TAKACHI ELECTRONICS ENCLOSURE CO., LTD.

NOTICE

NK and NKK Series Mold Renewal and Design Change

Change Details

② Shape

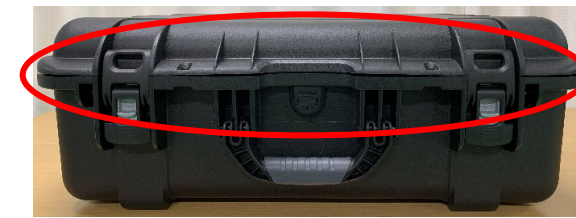
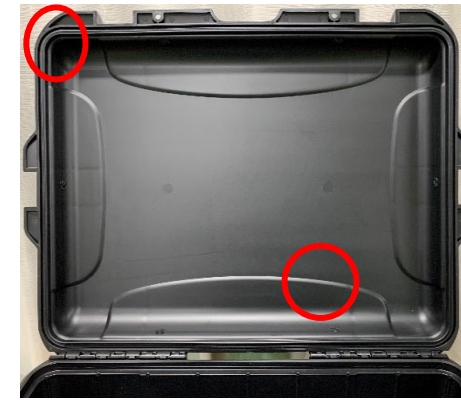
- 1** Built-in stainless steel reinforced hole for lock - hole position change and stainless steel parts added.
- 2** Handle grip - new wider handle grip and spring return function added.
- 3** Cavity removed.

- 4** Bosses for installation of optional panels added onto the inside rim of the cover.
- 5** Bosses are added inside of the cover.
- 6** Straight hinge pin modified to a new L-shape detachable hinge pin.
- 7** **8** Cover design changed to wrap around the opening base.
- 9** Design changed.
